SUNDRY NOTICES AND REPORTS ON WELLS

8. Well Name and No.
Cato San Andres Unit # 172

Cato San Andres Unit No. 172 SWD
Abandonment Program v.1
API Number: 30-005-20177-00-00
Cato San Andres [10540]

Cato San Andres Unit 172
30-005-20177
Shell Oil Company
June 14, 2023
Conditions of Approval

Proposed Well Bore Diagram after Abandonment Operations

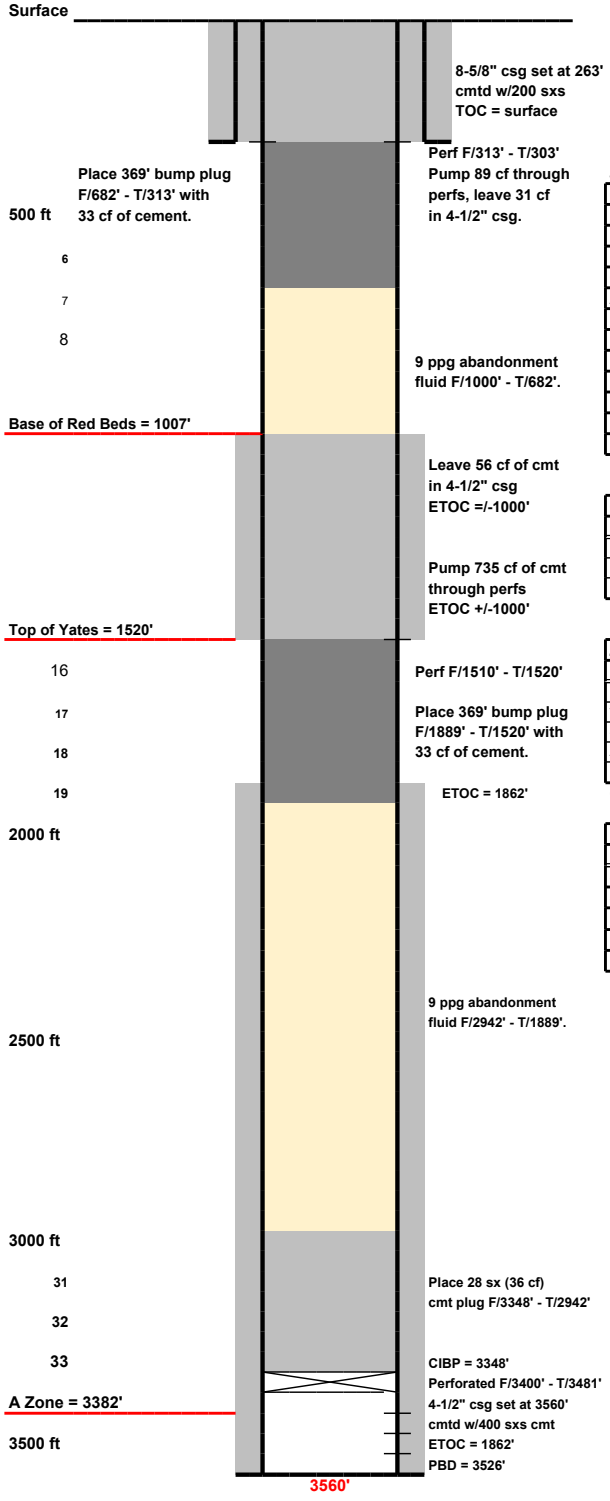
1. **Operator shall place CIBP at 3,348' (50'-100' above top most perf) and place a minimum of 25 sx of Class C cement on top. WOC and TAG.**

2. **Operator shall place a balanced Class C cement plug from 1,889' to 1,520' as proposed. WOC and TAG.**

3. **Operator shall perf at 1,520'and squeeze Class C cement to 1,000' to seal the Yates and the Salt Formations. WOC and TAG.**

4. **Operator shall perf at 313' and squeeze class c cement to surface to seal the 8-5/8'' casing shoe.**

5. **Dry hole marker must be below ground.**

Created By	Condition	Condition Date
loren.diede	After setting the WL-set CIBP, (Step 5 of Abandonment Program v.1) run CBL from 3348' to surface. Submit CBL to NMOCD via Electronic Permitting.	3/26/2024
loren.diede	Add cement plug to cover the San Andres formation top (2693') with a cement plug from 2743' to 2593'.	3/26/2024
loren.diede	Add cement plug to cover the Grayburg and Queen formation tops (2330' and 2170') with a cement plug from 2380' to 2070'.	3/26/2024
loren.diede	In lieu of the proposed plug from 1520' to 1007', isolate the Yates formation top (1520') with a plug from 1570' to 1420'. The results of the CBL will determine if the plug is to be an inside or inside / outside plug.	3/26/2024
loren.diede	In lieu of the proposed plug from 1520' to 1007', isolate the Rustler formation top (1008') with a cement plug from 1058' to 908'. The results of the CBL will determine if the plug is to be an inside or inside / outside plug.	3/26/2024
